DATE	JUNE 12, 97	JOB NO.	9545
ATTENTION	ADAM C. HOFF, P.E.		
RE:	HENRY COUNTY COURTHOUSE RENOVATION

Re: City of Napoleon
Henry County Courthouse
Renovation Project

Re: Henry County Courthouse
Renovations

FIRE PUMP WITH DOUBLE DETECTOR CHECK VALVE* ON NEW FIRE LINE.

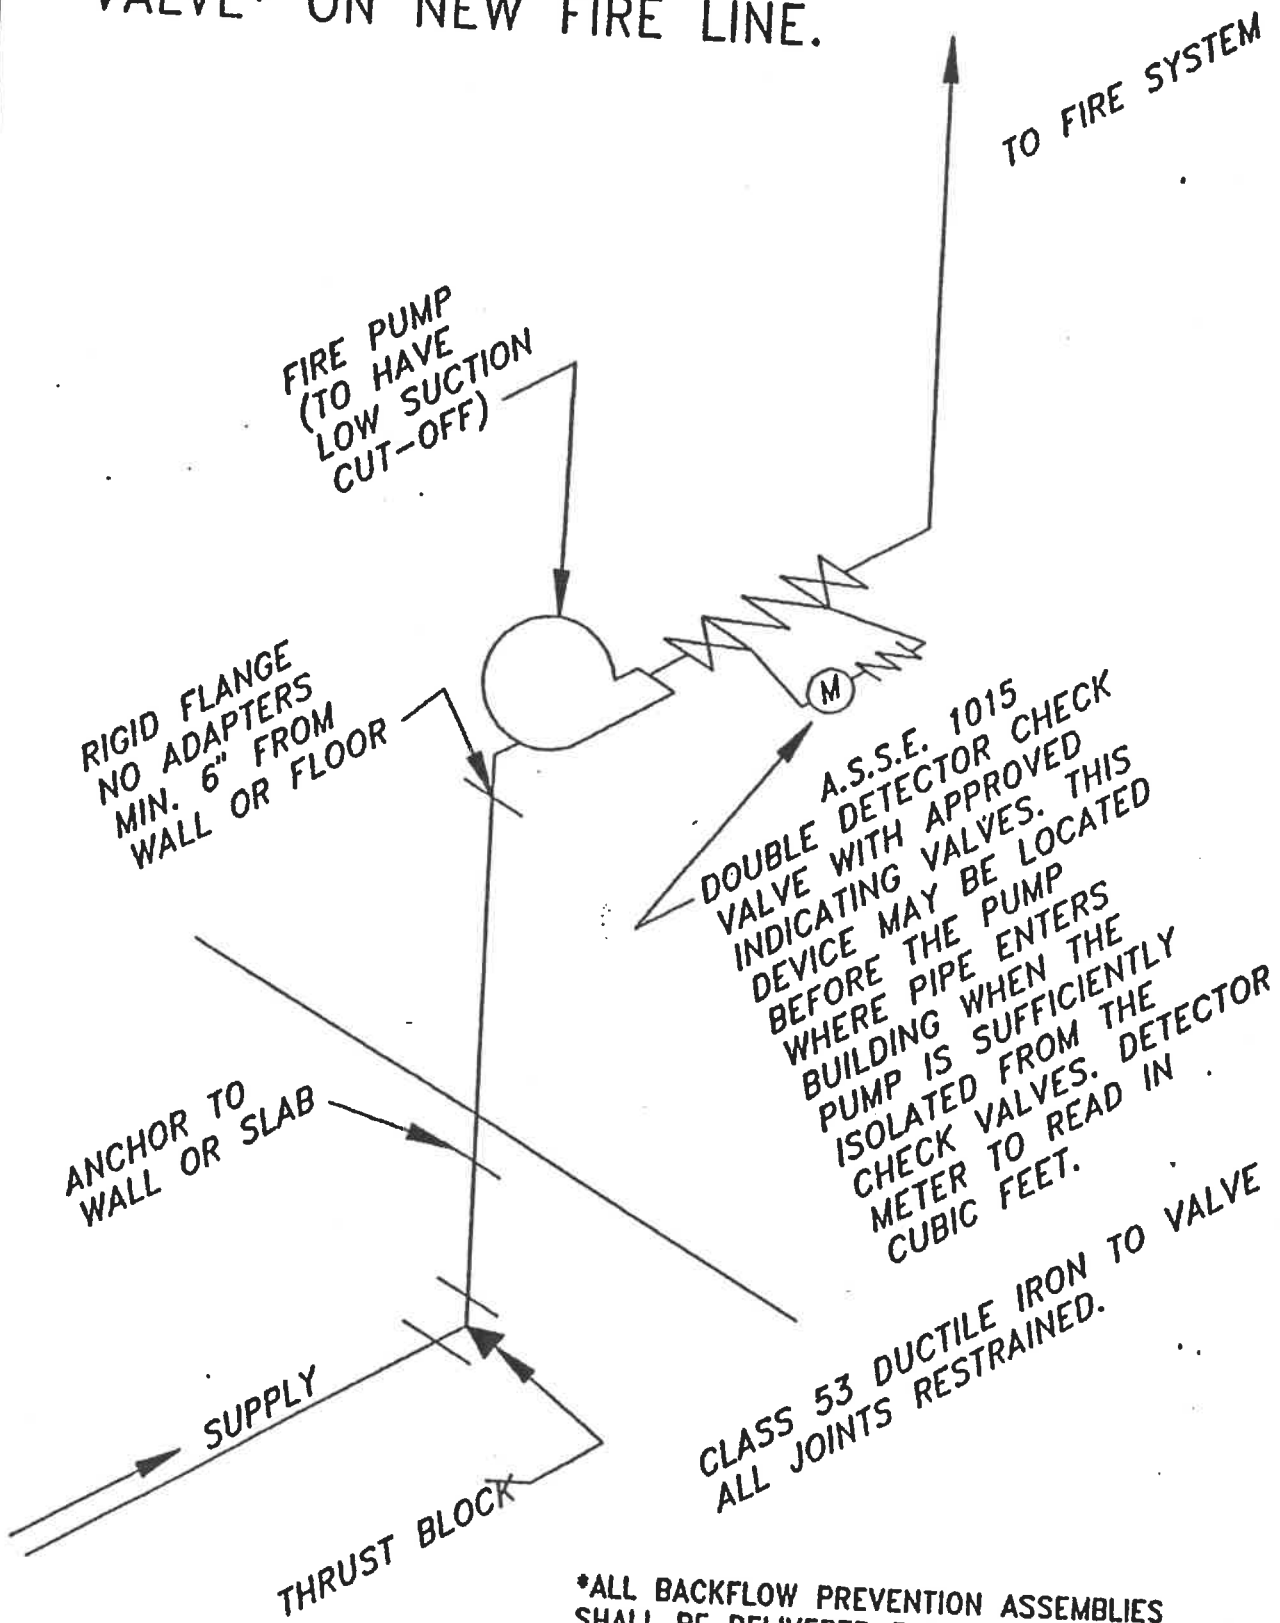
1. The hydrant flow test was performed on Wednesday, May 8, 1996 from hydrant #59, the static pressure was 70 psi., the residual was 60 psi., the hydrant was flowing at 1319 gpm., at this time the Water Treatment Plant had a 2,000 gpm. pump running and the elevated tank level was 23½ feet.
2. Please find attached the drawing as per your request for backflow requirements of the fire system booster pump.
3. The City will allow you to propose the use of the fire line for domestic water with the following provisions (1) that the City crews will tap the fire line and a curb stop shall be installed outside the building near the right-of-way; (2) the tap shall be subject to all usual tap fees normally charged by the City; (3) the 2" copper setter with bypass will be reused; (4) a reduced press backflow device shall be installed immediately after the copper setter, with proper drainage system.

*ALL BACKFLOW PREVENTION ASSEMBLIES SHALL BE DELIVERED FOR INSTALLATION COMPLETELY ASSEMBLED BY THE ORIGINAL MANUFACTURER WITH ALL COMPONENTS AS APPROVED.
